RLH CO 12-19 APPLICATION FOR APPEAL

CORRECTION NOTICE – FOSTER CARE INSPECTION

1955 HAWTHORNE AVE E

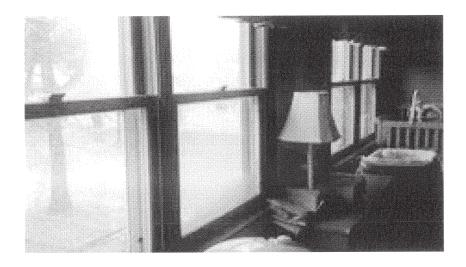
I would like to appeal the determination that the window sizes in the second floor north east bedroom are in-adequate to provide foster care within my home.

There are four of the said windows with a openable area of 20.5 inches high by 30 inches wide. The size of the window openings exceed the statute that states the windows should be a minimum of 24 inches high by 20 inches wide. Please notice the picture provided below of these 4 windows. As you can see, these windows are simply "turned sideways" in that the openable area is wider rather than higher.

Required: 24" by 20" = 480 square inches of openable area

Current, existing windows: 20.5" by 30" = 615 square inches of openable area

*BEDROOM EGRESS WINDOWS - OPENABLE DIMENSIONS - MSFC1026.1 - Provide and 1. maintain an approved escape window from each sleeping room. The minimum size must be 5 square feet of glazed area with a minimum of 24 inches of openable height and 20 inches of openable width. With a finished sill height not more than 48 inches. Refer to the Escape Windows for Residential Occupancies handout for more information.-The second floor north east bedroom has four windows all with openable dimensions of 20.5 inches high by 30 inches wide.
